MIL-R-83516A(USAF)
AMENDMENT 3
23 FEBRUARY 1984
~~SUPERSEDING~~
AMENDMENT 2
28 September 1983

RELAYS, REED, DRY, GENERAL SPECIFICATION FOR

This amendment forms a part of Military Specification MIL-R-83516A(USAF), dated 3 March 1983, and is approved for use by the Department of the Air Force and is available for use by all Departments and Agencies of the Department of Defense.

FIGURE 1. Typical circuit for operate and release time and contact bounce with typical traces.

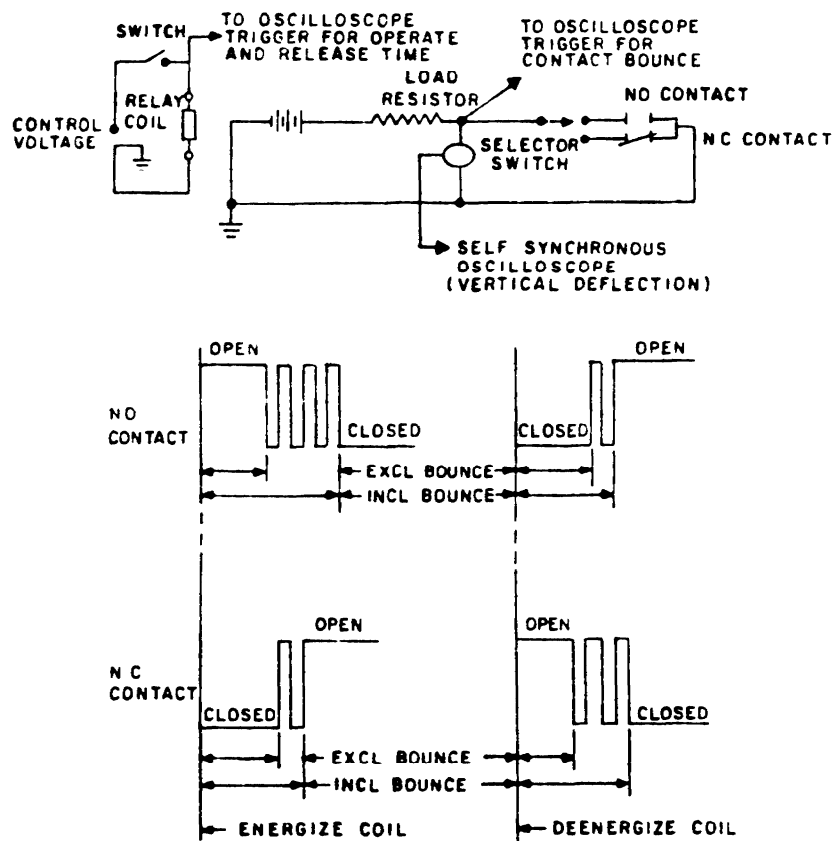
FIGURE 1: Delete and substitute new figure 1 as printed on page 2 of this amendment.
